SERVICE BULLETIN

Classification: EM09-007	Reference: NTB09-128	Date: November 16, 2009
-----------------------------	-------------------------	----------------------------

PATHFINDER / XTERRA / FRONTIER; BUZZING / WHINING NOISE FROM TIMING CHAIN AREA

APPLIED VEHICLES: 2005-2010 Pathfinder (R51) VQ40 engine ONLY
2005-2010 Xterra (N50)
2005-2010 Frontier (D40) VQ40 engine ONLY

Figure 1

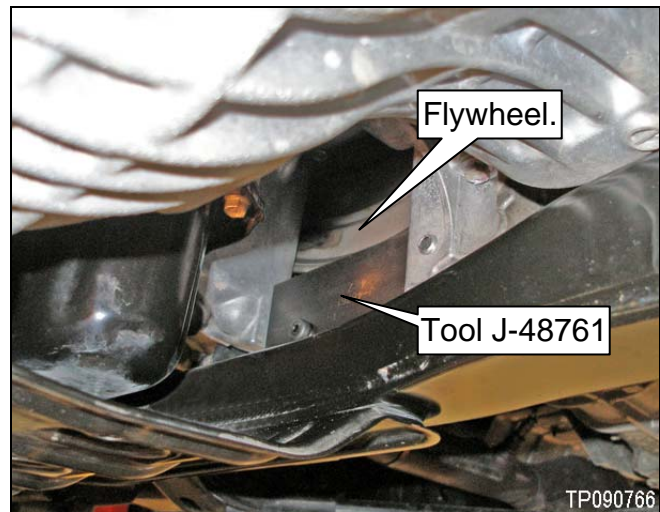
- Before removing the crankshaft pulley, set it to 0° Top Dead Center (TDC).
- Use Tool J-48761 to secure the flywheel / flex plate when removing the crankshaft pulley and camshaft sprockets. Figure 1 shows J-48761 installed on an AWD vehicle.

Figure 2

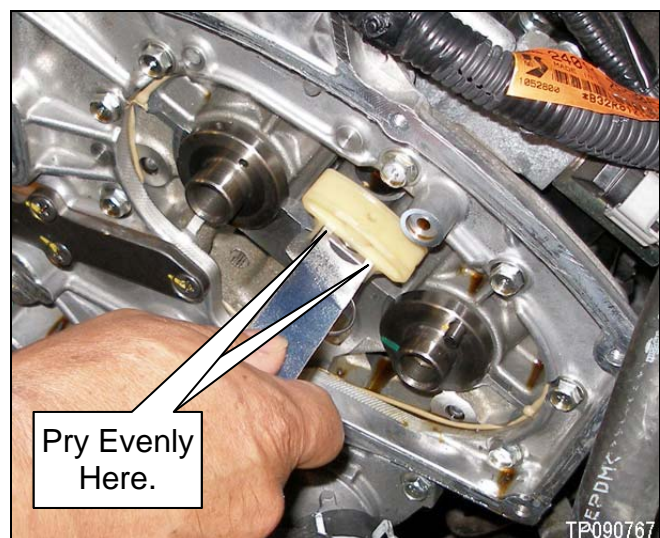
- Remove the Secondary Timing Chain Tensioner Shoes (shoe) by evenly prying with a couple pocket screwdrivers or suitable tool where shown in Figure 2.

Figure 3

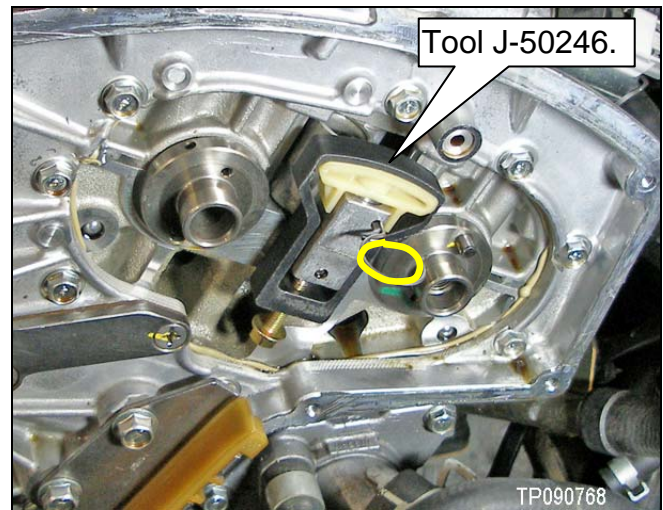
- If the crankshaft is determined to be 360° off from 0° TDC on #1 cylinder compression stroke after removing the front timing chain case (front cover), put the crankshaft pulley back on, and then rotate the crankshaft 360° (when camshaft and crankshaft sprocket mating marks are aligned).
- Use the chain tensioner pins (pin) from Tool Kit J-50246 to hold all three (3) chain tensioner plungers. Figure 3 on Page 5 shows a pin used on B2 tensioner.

5. Install the new shoes to the tensioners with Tool J-50246 (see Figure 3).

- Tighten the bolt until the shoe is fully seated.

CAUTION: Tighten the bolt no more than necessary.
